SERVICE BULLETIN

SB1360A

SUBJECT : Introduction of new rubber-metal mounts for engine

suspension

Figure 1: Visual identification of rubber-metal mount

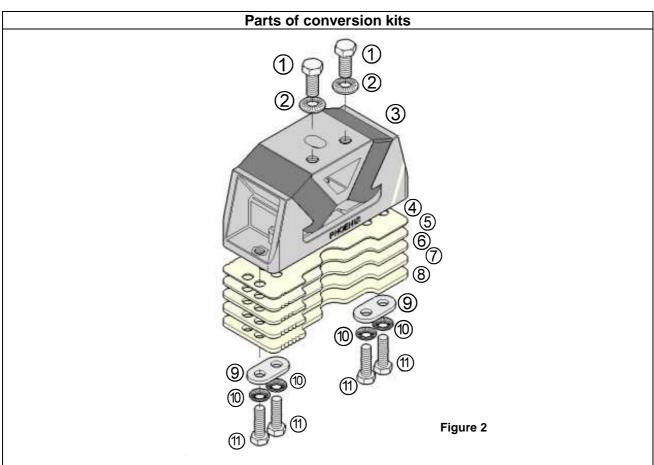
Van Hool has changed-over in production to a new type of front rubber-metal mount for the engine suspension. As the new type can also be used on previously sold vehicles, only the new type will continue to be available as a spare part. Please refer to the material list and step-by-step instructions from the procedure below when installing this new type of rubber-metal mount. The new type of rubber-metal mount is available in the hardness "45-A-Shore" and "50-A-Shore". Which hardness must be used can be found in the spare parts manual of the vehicle.

NOTE: Rubber-metal mount "45-A-Shore" replaces the old "55-A-Shore" rubber-metal mount VH11222466, rubber-metal mount "50-A-Shore" replaces the old "60-A-Shore" rubber-metal mount VH11222467.

- A. Old type
- B. New type
